Transport for NSW submission on
the draft IPG Badgerys Creek Road
Master Plan

Re: Exhibition of the IPG Badgerys Creek Road Master Plan (WSA_MP01) 13 December 2024

Sydney Water comments on WSA_MP01 IPG Badgerys Creek Rd Master Plan at 475 Badgerys Creek, Bradfield (Proposed by Ingham Property Group)

**Inghams Property Group Master Plan WSA_MP01
475 Badgerys Creek Road, Bradfield**

Figure 3 – Current Precinct Plan Heights vs Proposed Master Plan Heights

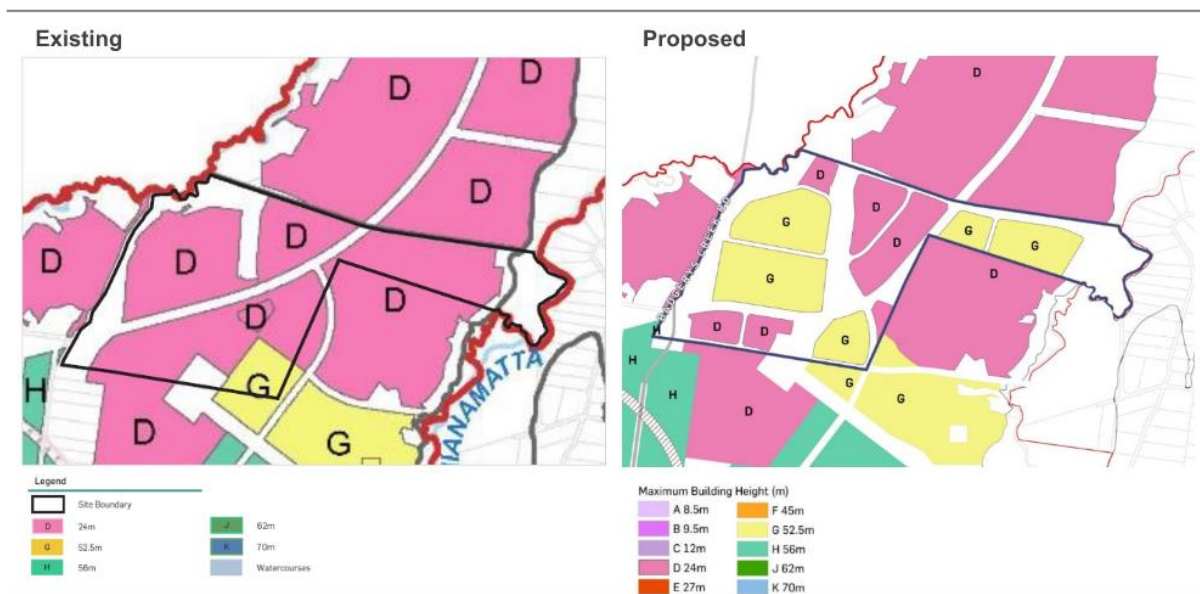
Comments:

Lot Numbers	Building Height as per Figure 1	Highest Ground Level in Lots (AHD)	Highest Building Point (m) AHD	Highest Building Point incl. Plant (m) AHD
1 – 4 inclusive	24m (pink shading)	72.5m	96.5m	97.5m
5 – 10 inclusive	52.5m (yellow hatched shading)	70.5m	123.0	124.0m
11	24m (pink shading)	61.0m	85.0m	86.0m
12 – 18 inclusive, and 23	24m (pink shading)	71.5m	95.5m	96.5m
19 – 22 inclusive	52.5m (yellow hatched shading)	68.0m	120.5m	121.5m
24 – 25 inclusive	52.5m (yellow shading)	71.0m	123.5m	124.5m

Based on the above analysis by the proponent, the proposed building height will not penetrate the Obstacle Limitation Surface (OLS) which is 126m (AHD). However, the assumption that building plant will be no more than 1m higher than the building (presumably roof) is likely underestimating the height of roof top building plant.
